**Proposed Plan
for Soil, Sediment, and Surface Water
at RVAAP-13 Building 1200**

**Ravenna Army Ammunition Plant
Ravenna, Ohio**

**DRAFT PROPOSED PLAN FOR SOIL, SEDIMENT, AND SURFACE WATER AT THE RVAAP-13 BUILDING 1200
RAVENNA ARMY AMMUNITION PLANT, RAVENNA OHIO
COMMENT RESPONSE TABLE ~ REVISION 0**

Figure 3. Building 1200 AOC Site Features

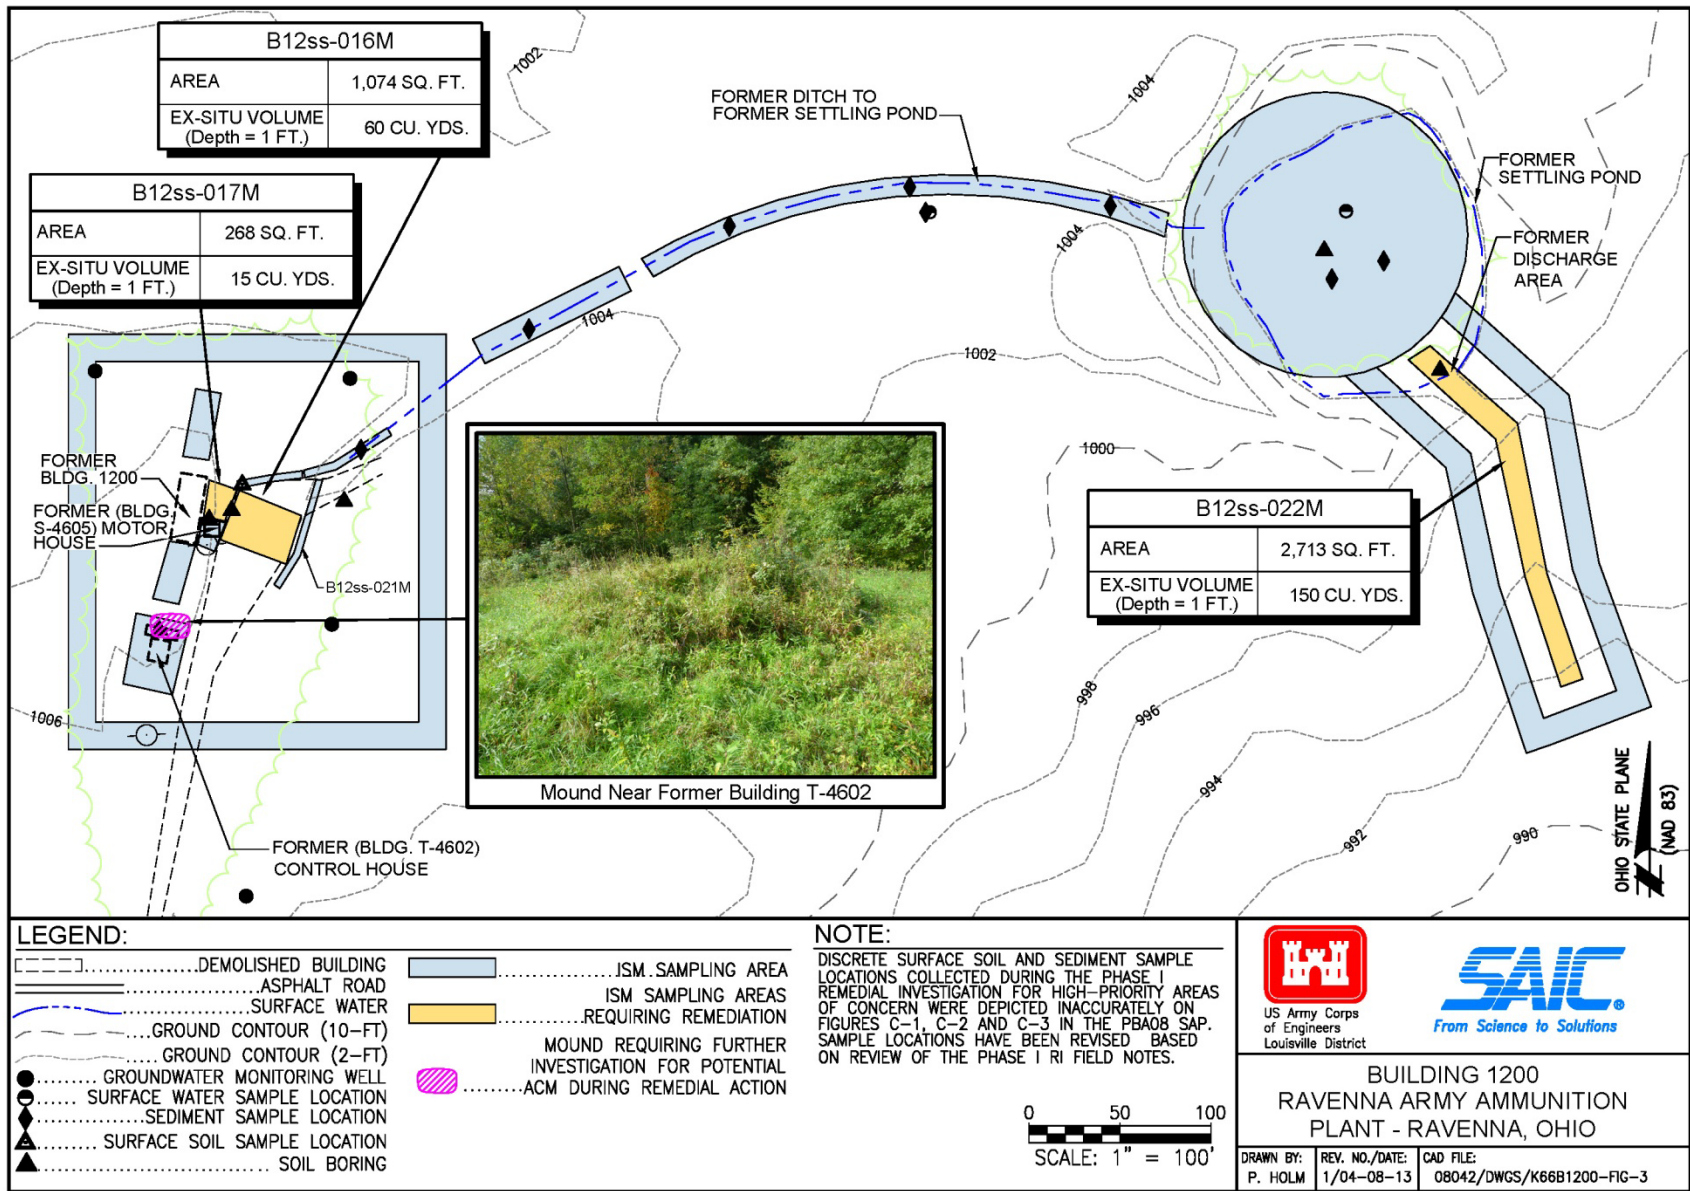
Comment Number	Page or Sheet	Comment	Recommendation	Response
O-4.	Page 16, Figure 3	Please include the location of the mound to be evaluated for asbestos containing material (ACM) and the area that includes sample B12ss-022M (highlighted in orange – “Requiring Remediation”).		Agree. The location and a photo of the mound requiring evaluation of ACM has been added to Figure 3. Please see response to comment O-2 for the recommended remedial action.
